Burnley Technology, Inc.

17 June 1994

We are writing to request a revision to USNRC Certificate of Compliance Number 9245 issued for the Model 420 Package. We have determined that an error existed in the original RTS Technology, Inc. application for this package relating to the thickness of the insulating liner and we ask that this be corrected.

We request that Certificate of Compliance Number 9245 be revised to reflect that the side insulation have a thickness of 1.5 inches.

Material	Noted	Unless otherwise noted, tolerances shall be: X.X : ± 0.1 X.XX : ± 0.01 X.XXX : ± 0.005 Angles: ± 0.5°	Title Model 420 Package Assy (Model 424 Inner)	
Finish	Painted		No. 42400 Rev. 0	
Drawn by:	<i>[Signature]</i>			
Checked	<i>AOS</i>			
Approved				
Scale	1:4

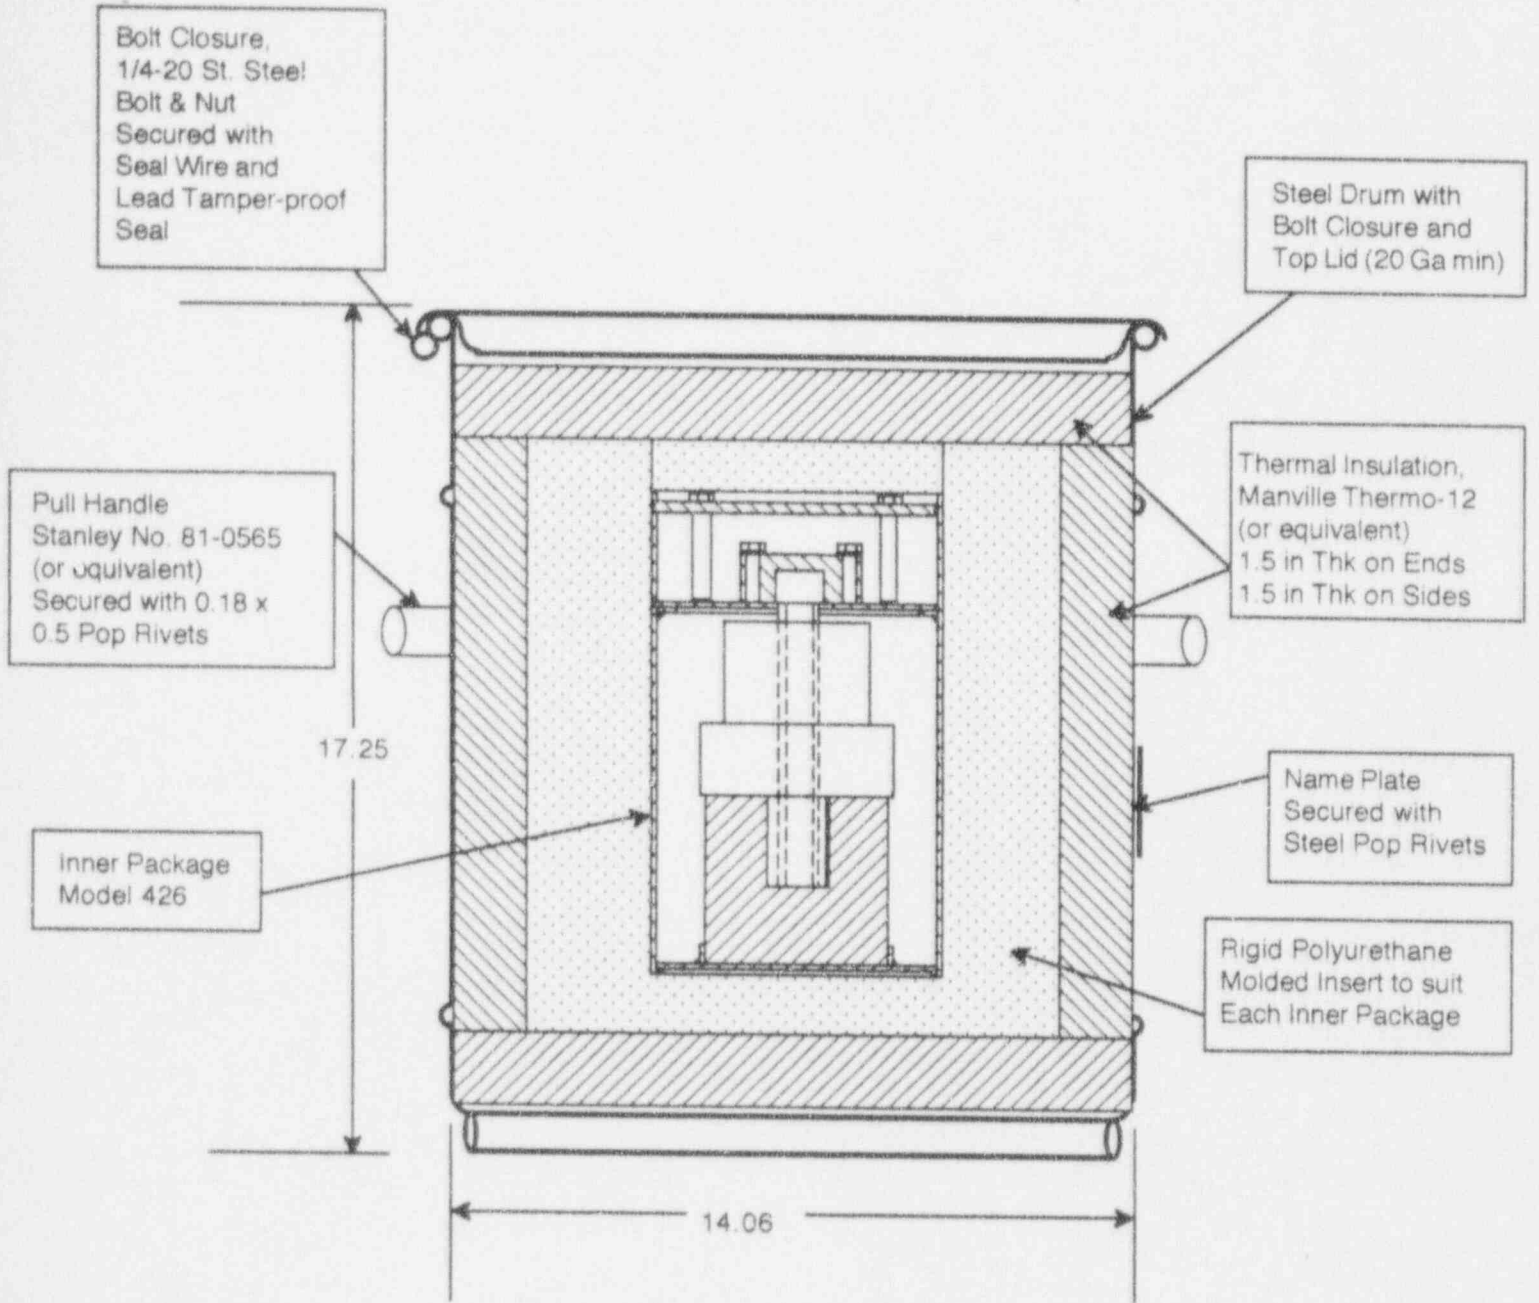
We request that Certificate of Compliance Number 9245 be revised to reflect that the side insulation have a thickness of 1.5 inches.

We are enclosing Burnley Technology, Inc. Drawings 42400, Rev. 0, Drawings 42500, Rev. 0, and Drawings 42600, Rev. 0 which reflect this 1.5 inch thickness of insulation. We ask that these drawings be referenced in Certificate of Compliance Number 9245, and that references to RTS Technology, Inc. Drawings 42471, Rev. 0, 6717B, Rev. 0, 42400, Rev. 0, 42500, Rev. 0, and 42600, Rev. 0 be deleted. We also ask that the description of section 5.(a).(2) be revised to reflect this thickness of insulation.
